TB-20111206

Subject: The cancellation of the oil temperature well on the oil separator for Hanbell RC2-series compressor (model: RC2-1020 、 1130 、 1270 、 1530 excluded)

Thermal well hole on oil separator of RC2-100 、 140 、 180.

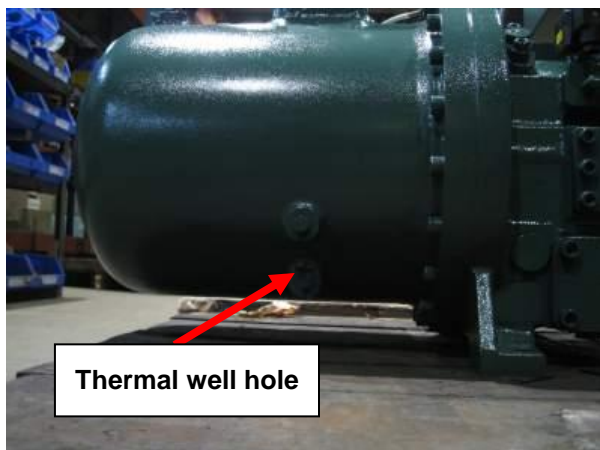
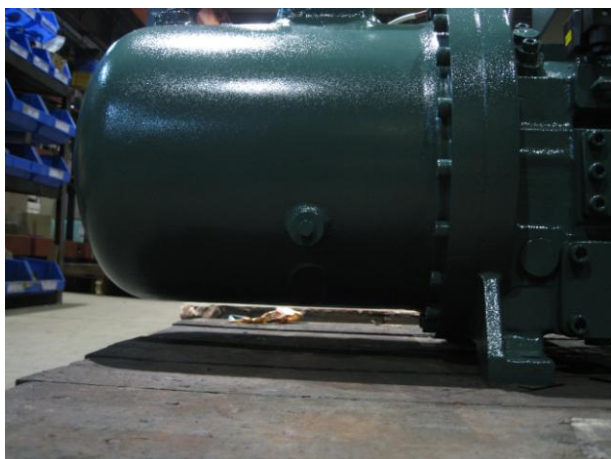
No thermal well hole on oil separator of RC2-100 、 140 、 180.

Thermal well hole on oil separator of RC2-170~620 (180、610 excluded)

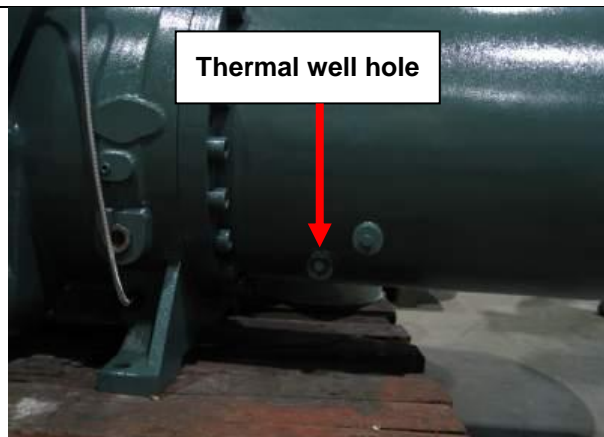
No thermal well hole on oil separator of RC2-170~620 (180、610 excluded)
